STATE OF NORTH CAROLINA
DEPARTMENT OF TRANSPORTATION

Subject: Modification Request for the Nationwide 14 Permit and Water Quality Certification for Improvements to US 17 from Mills Street in Bridgeton to Norfolk & Southern Railroad, Craven County. State Project: 8.117601. Federal Aid Project: STPNHF-17(24). TIP: R-3403AA. Debit \$570.00 from WBS 34538.1.1

The purpose of this letter is to request modifications to the Clean Water Act (CWA) Section 404 Permit issued by the USACE and the Water Quality Certification issued by the NCDWQ. This project is due to let on September 21, 2010. The North Carolina Department of Transportation (NCDOT) is proposing the following modifications:

Revised 6/14/10
Permit Drawing Sheet 5 of 13

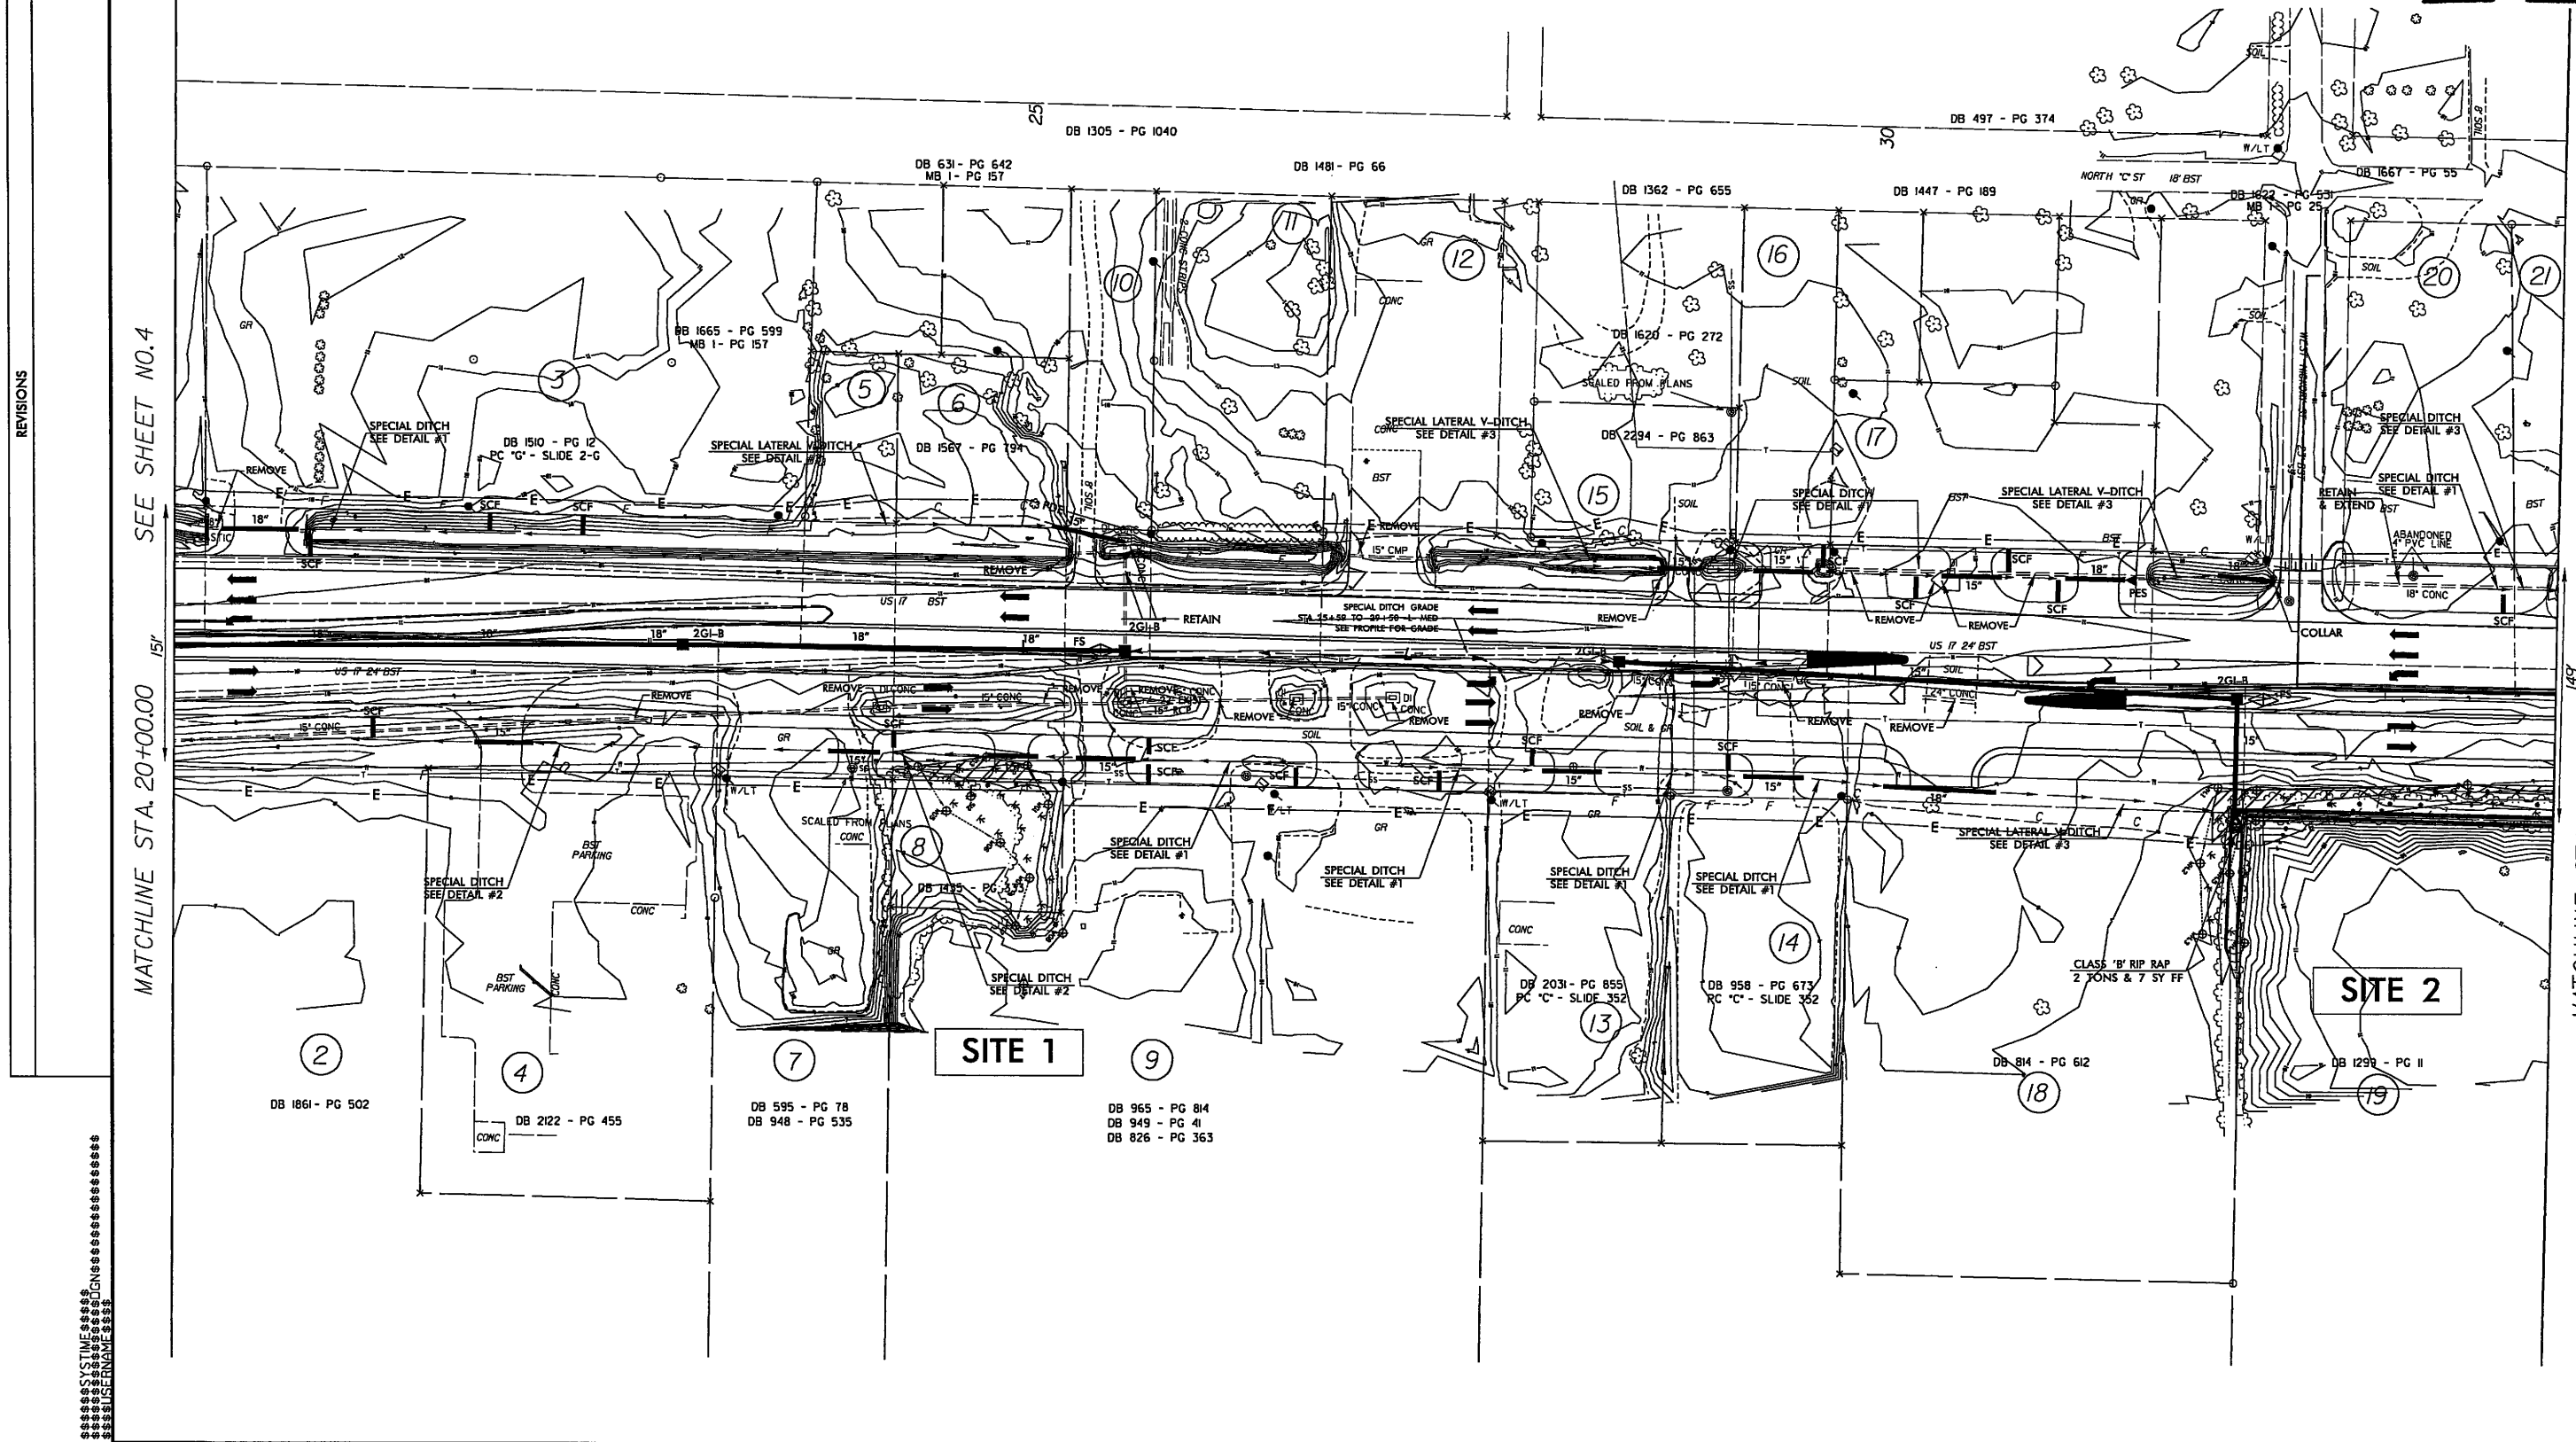
- The addition of curb and gutter results in a decrease of 0.11 acre of wetland impacts.

The wetland at site 1 will be partially filled by proposed curbing for a roadside ditch and a driveway entrance. No new stormwater will be entering the wetland at site 1.

Revised 6/14/10
Permit Drawing
Sheet **6** of **13**

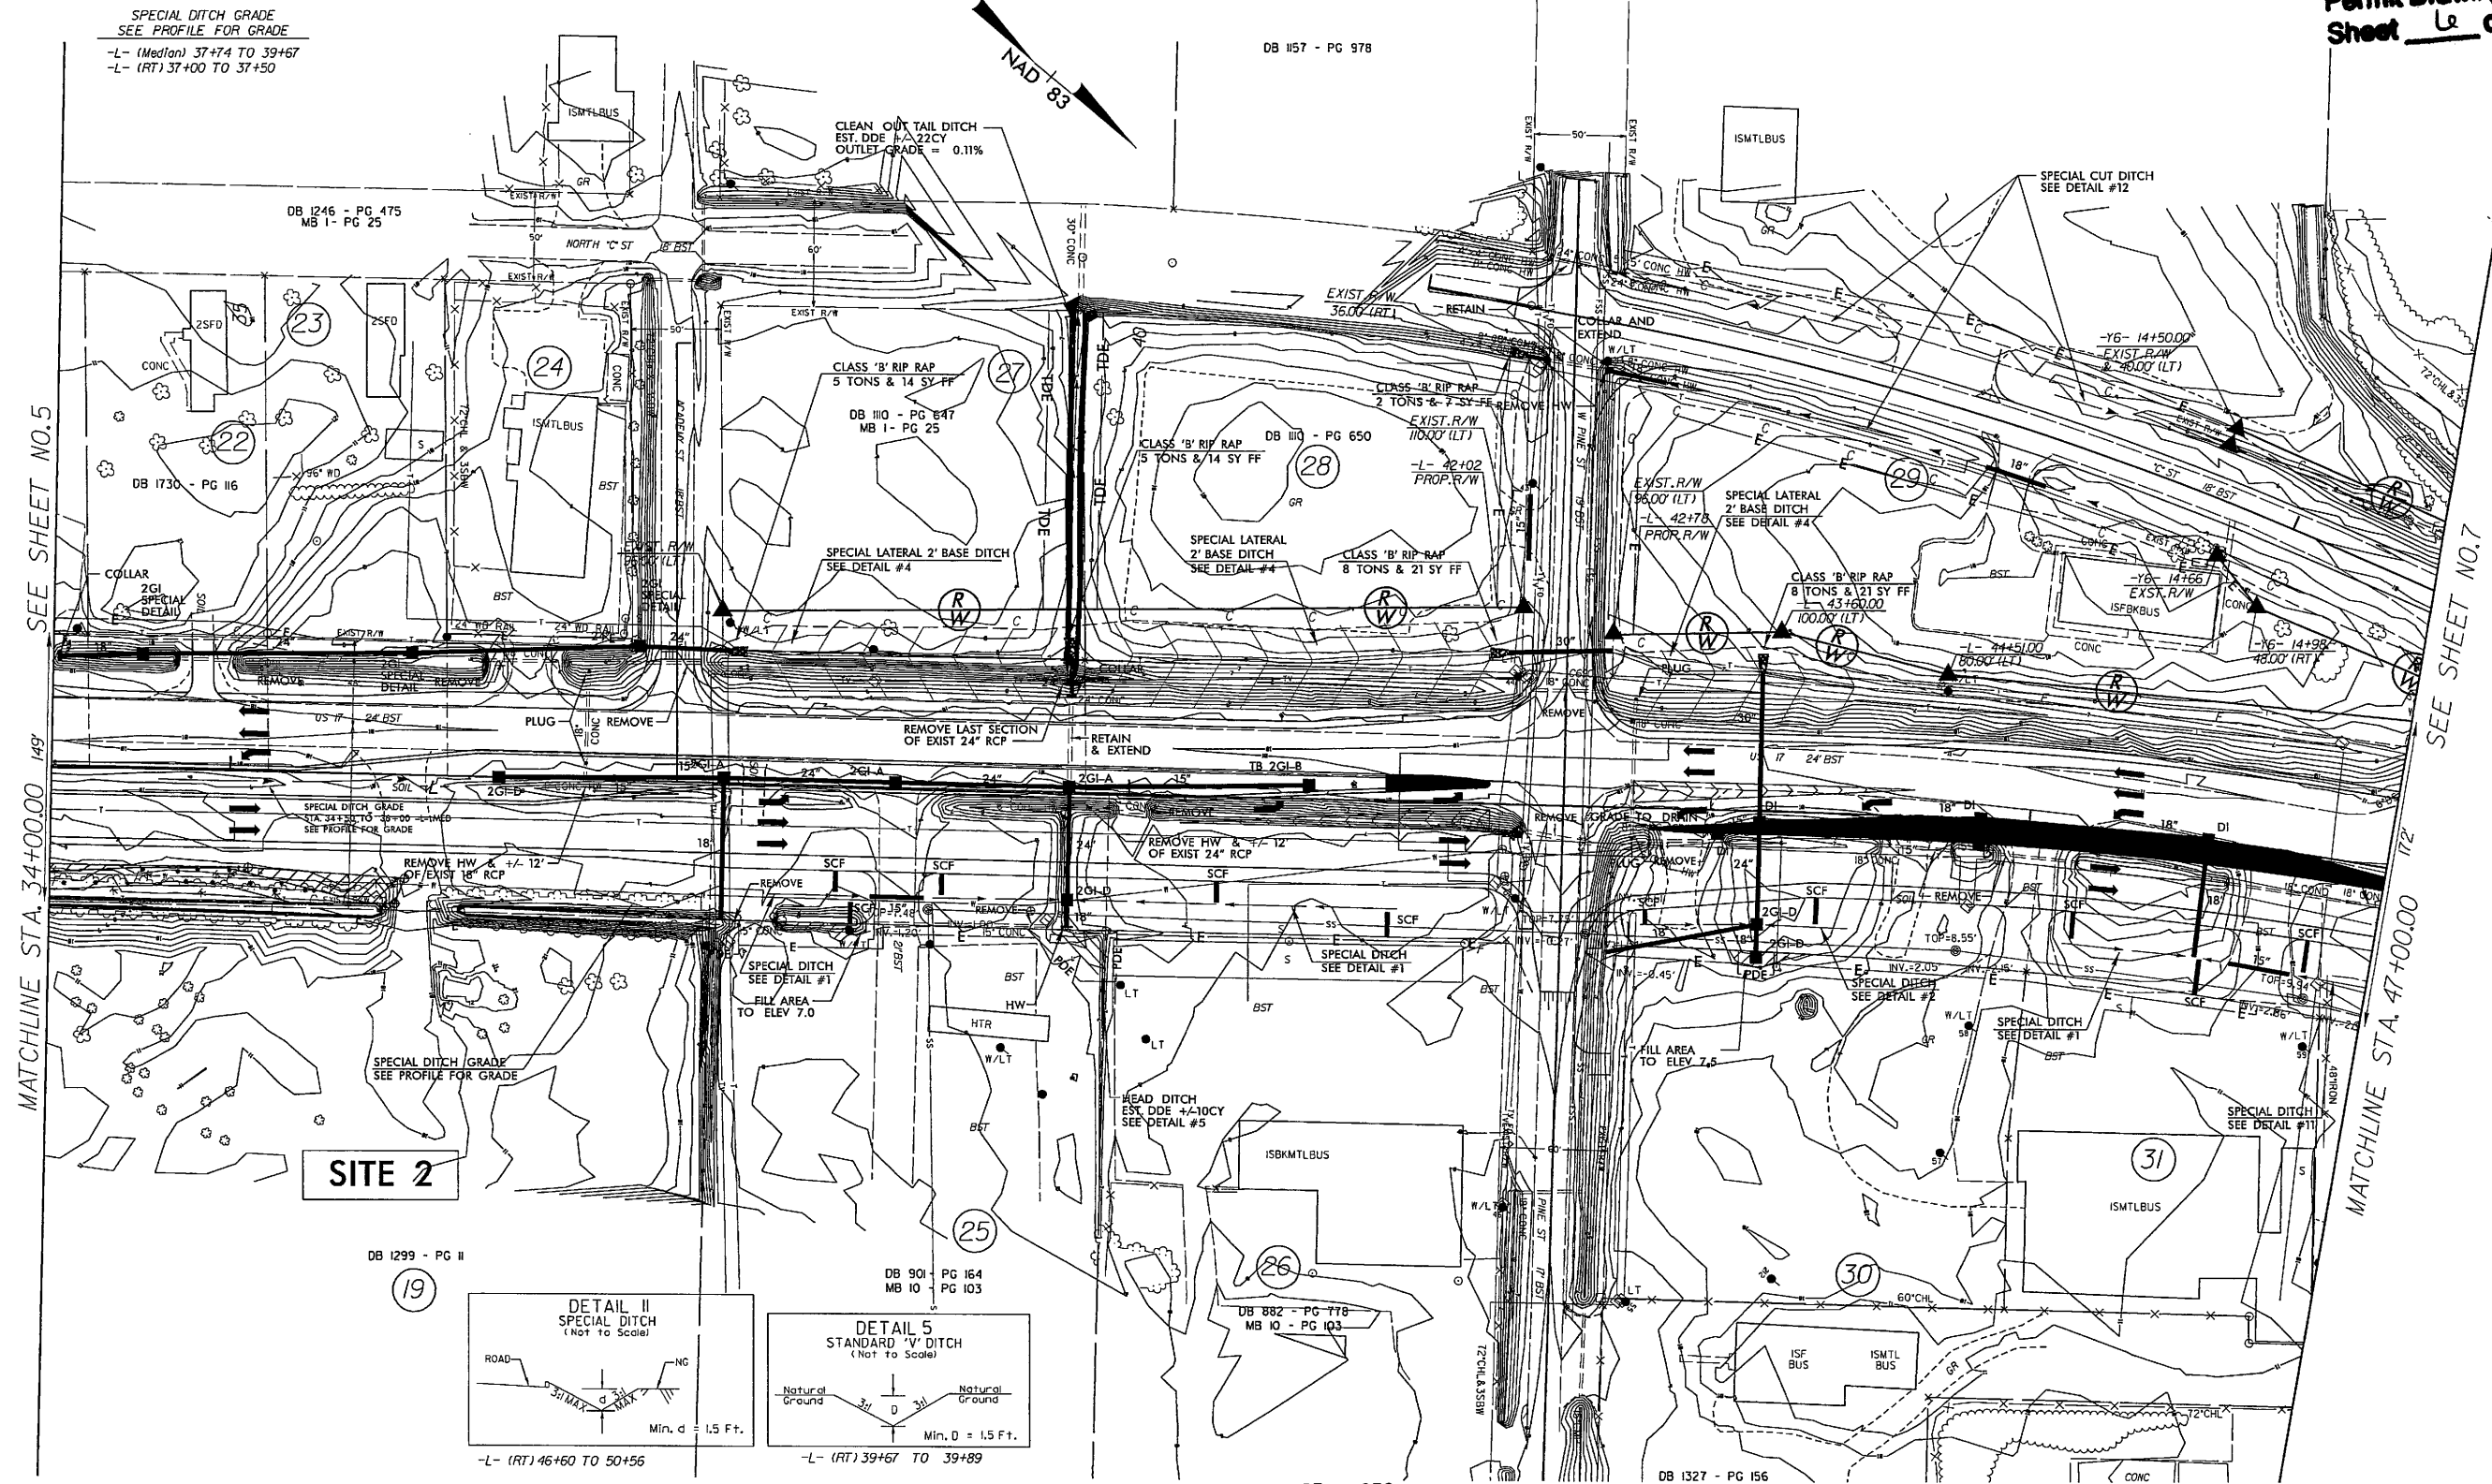
The wetland at site 2 will receive stormwater from median inlets at station 28+50-L-, 32+13-L- and a roadside grassed swale. Stormwater entering the median inlets is treated by grassed swales from station 27+00 to 29+50 -L- and from station 31+47 to 32+13 -L-. The roadside grassed swale is treating stormwater from station 27+09 to 32+13 -L- RT. As shown in the attached calculations, all 2yr velocities in the grassed swales are under 2ft/s. Although the velocity of stormwater exiting the system into the wetland during the 10yr design storm is 2.8ft/s, class 'B' rip rap will be placed at the pipe outlet to dissipate flow. Further, the 10yr velocity in the roadside grassed swale is 1.8ft/s, meeting criteria for diffuse flow into the wetland.
